S-4989
MAUCH MAJOR SUBDIVISION, A REPLAT OF LOT 1
(major-preliminary)

STAFF REPORT
April 15, 2021

MAUCH MAJOR SUBDIVISION REPLAT OF LOT 1
Major-Preliminary Plat

Staff Report
April 15, 2021

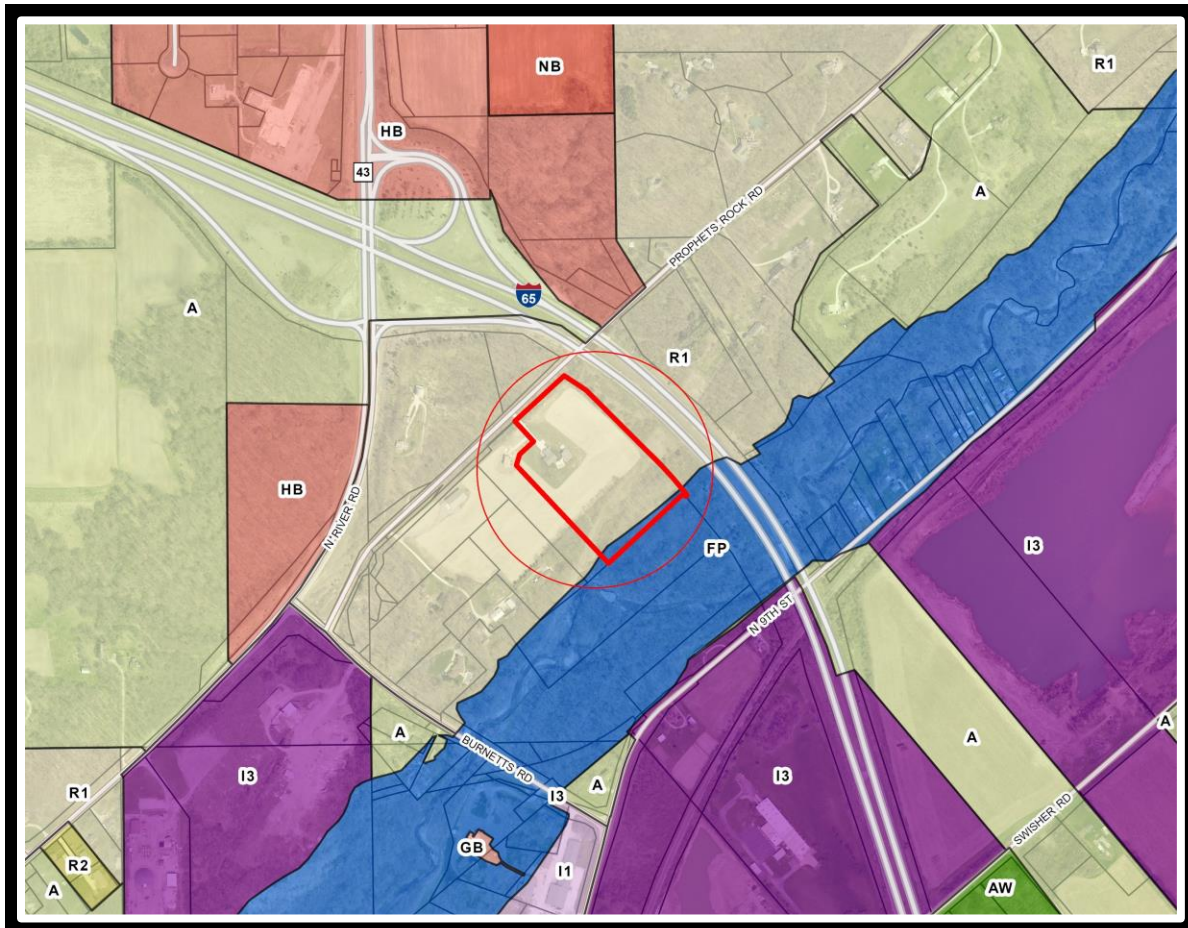
All of the building setbacks are shown correctly except for the southwest lot line of Lot 1B. It is shown as a 6-ft side setback, but should be a 25-ft rear setback. Each lot exceeds the lot width and area standards for the R1 zone.

1. Except for the approved entrance, a "No Vehicular Access" statement shall be platted along the Prophets Rock Road right-of-way line.
2. All existing easements, covenants or restrictions shall be shown and referenced with the corresponding recording information (Document Number and date recorded).
3. All required building setbacks shall be platted.
4. The Regulatory Flood Elevation and Boundary for the Burnetts Creek Flood Plain shall be shown.
5. The street addresses and County Auditor's Key Number shall be shown.
